Access Compliance Report

Public Rights-of-Way

(Curb Ramps)

Intersection ID: 3556	Main Street: PROSPERITY_CHURCH_RD	Cross Street: WHITE_CASCADE_DR	Location:	N
ADA ID: 6D7BDEA8C520	Ramp Type: PerpDiag	Initial Pass/Fail: Fail	Overall Compliance: No	Severity Score: 26.25
Codes/Mitigation Info/Possible Solution		Field Measurements/Component Compliance

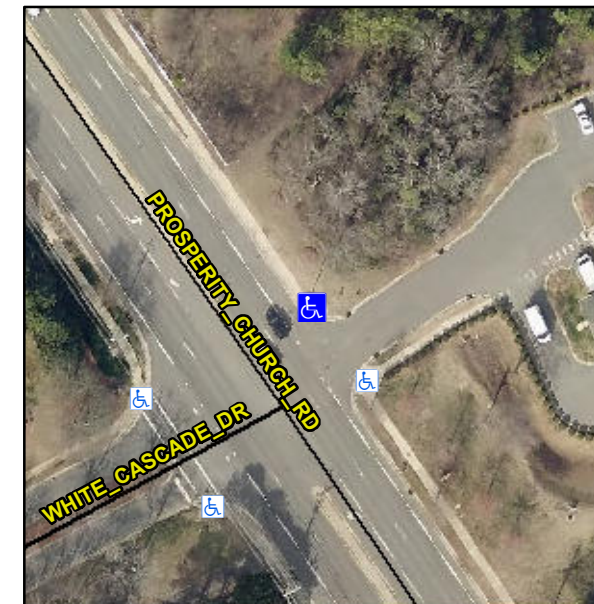
R304.2.2, R304.5.3

Compliance	Description	Data	Compliance	Description	Data
N/A	Ramp Length (in)	66.5	No	Ramp Slope (%)	12.1
Yes	Ramp Width (in)	48.0	No	Ramp XSlope (%)	2.8
N/A	Flare Type LT	N/A	N/A	Flare Type RT	N/A
N/A	Flare Slope LT (%)	N/A	N/A	Flare Slope RT (%)	N/A
N/A	Flare Traversable LT?	N/A	N/A	Flare Traversable RT?	N/A
N/A	Landing Length (in)	N/A	N/A	DWS Provided?	N/A
N/A	Landing Width (in)	N/A	N/A	DWS Contrast?	N/A
N/A	Landing Slope (%)	N/A	N/A	DWS Length (in)	N/A
N/A	Landing X Slope (%)	N/A	N/A	DWS Full Width?	N/A
N/A	Landing Curb? (Y/N)	N/A	N/A	DWS Offset (in)	N/A
N/A	Shared Landing?	N/A			
N/A	Gutter Ponding?	N/A	N/A	Gutter Slope (%)	N/A
N/A	Gutter Lip Ht (in)	N/A	N/A	Gutter X Slope (%)	N/A
N/A	Painted X Walk1?	No	N/A	Painted X Walk2?	No
	X Walk 1 Direction	To SW		X Walk 2 Direction	To SE
N/A	X Walk 1 Width (in)	N/A	N/A	X Walk 2 Width (in)	N/A
	X Walk 1 Slope (%)	1.9		X Walk 2 Slope (%)	1.0
	X Walk 1 X Slope (%)	0.7		X Walk 2 X Slope (%)	4.4

Remove & Replace Curb Ramp With Two New Directional Ramps or Equivalent.
